Serial No. 13-621  
NSSL/MLC R0  
Docket No. 50-423  
License No. NPF-49

Response to Request for Additional Information Regarding License Amendment  
Request to Revise Technical Specification 6.8.4.f for Peak Calculated Containment  
Internal Pressure

**DOMINION NUCLEAR CONNECTICUT, INC.  
MILLSTONE POWER STATION UNIT 3**

**Figure 1**

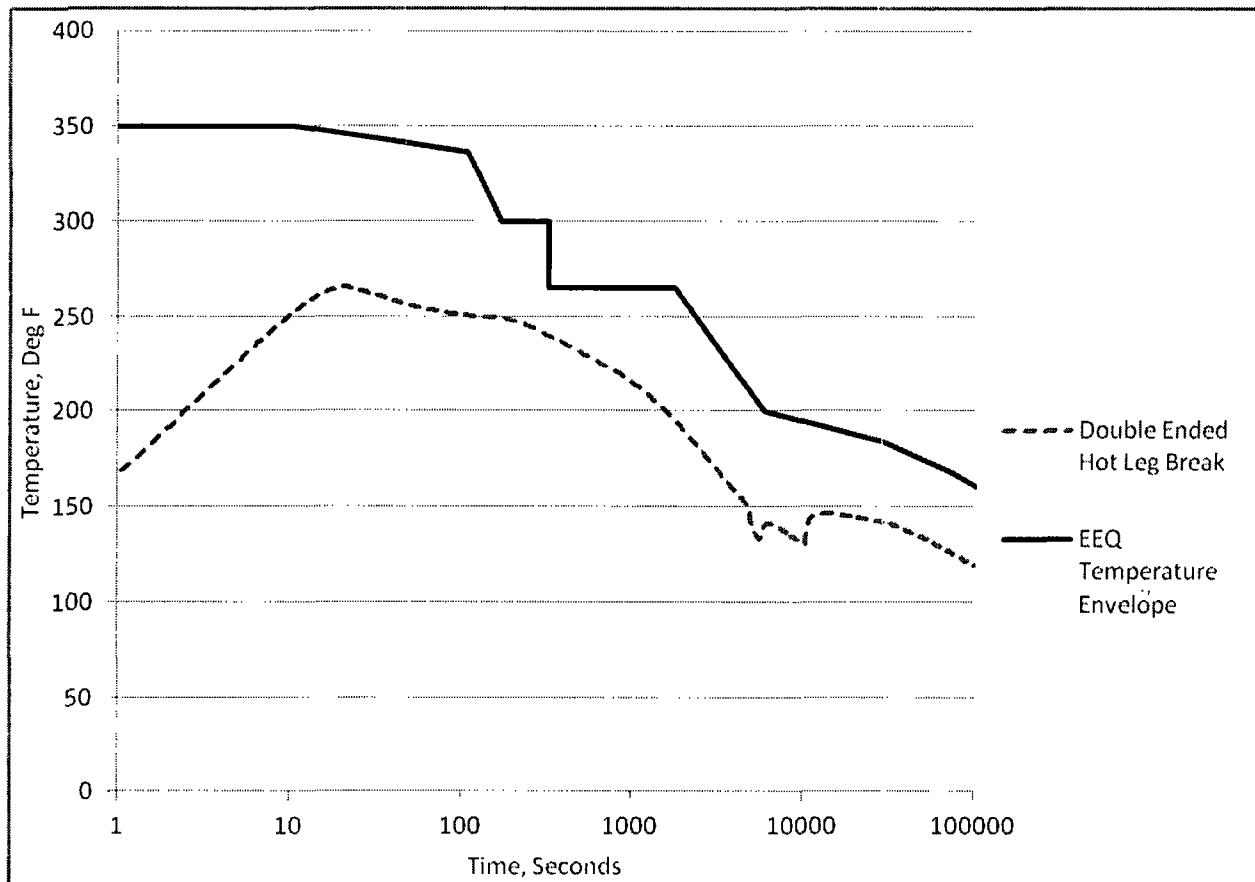
- a. Provide a discussion of the Environmental Qualification (EQ) re-analysis performed to show that the equipment remained qualified. In addition, provide a comparison of the EQ overlays with containment temperature and pressure profiles.*
- b. Explain how margins are being maintained for qualified equipment in accordance with 10 CFR 50.49.*

- a. The EQ bounding temperature profile taken from the MPS3 Environmental Specification (SP-M3-EE-0333) is used for the environmental qualification of plant equipment. The most limiting LOCA for peak containment pressure and temperature is a double-ended guillotine break of the hot leg. The containment peak pressure for this break has resulted in the current request to increase  $P_a$ . Figure 1 shows that the EQ bounding temperature profile envelopes the containment temperature profile from the double-ended hot leg break analysis. Therefore, there is no impact on the existing MPS3 EQ program, and the EQ program remains in compliance with 10 CFR 50.49.
